FS107-21

2021 International Building Code

SECTION 723 STRUCTURAL FIRE ENGINEERING.

FIGURE 722.5.1(5)
WIDE FLANGE STRUCTURAL STEEL COLUMNS WITH SPRAYED FIRE-RESISTIVE RESISTANT MATERIALS

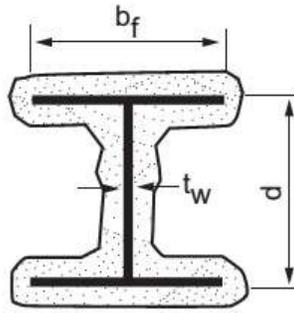
722.5.1.3 Sprayed fire-resistant materials (SFRM). The fire resistance of wide-flange structural steel columns protected with SFRM sprayed fire-resistant materials, as illustrated in Figure 722.5.1(5), shall be permitted to be determined from the following expression:

Reason Statement: The purpose of this proposal is to change the definition from Sprayed Fire-Resistant Materials to Sprayed Fire-Resistive Materials (SFRM). The reason for the change is to align the IBC definition with the industry term for the products. The National Fireproofing Contractors Association's Handbook of Accepted Fireproofing Knowledge (HAFK) uses the term SFRM - Sprayed Fire-Resistive Materials. Secondly, the listing directories refer to "Fire-Resistive" rather than "Fire-Resistant" materials. Several IBC Chapter 7 sections use the term "Fire-Resistive", including fire-resistive glazing and door sections in the Opening Protectives Chapter. Finally, the abbreviations in Chapter 17 follow formatting for other sections (example; Exterior Insulation Finish System (EIFS)).

722.5.1.3 Sprayed fire-resistive materials.(SFRM). The *fire resistance* of wide-flange structural steel columns protected with SFRM , as illustrated in Figure 722.5.1(5), shall be permitted to be determined from the following expression:

Committee Reason: The committee concluded the modification fixes the main proposal text regarding using "fire-resistive" instead of "fire-resistant". Committee approval is in line with committee action on code change G 17-21. (Vote: 13-0)
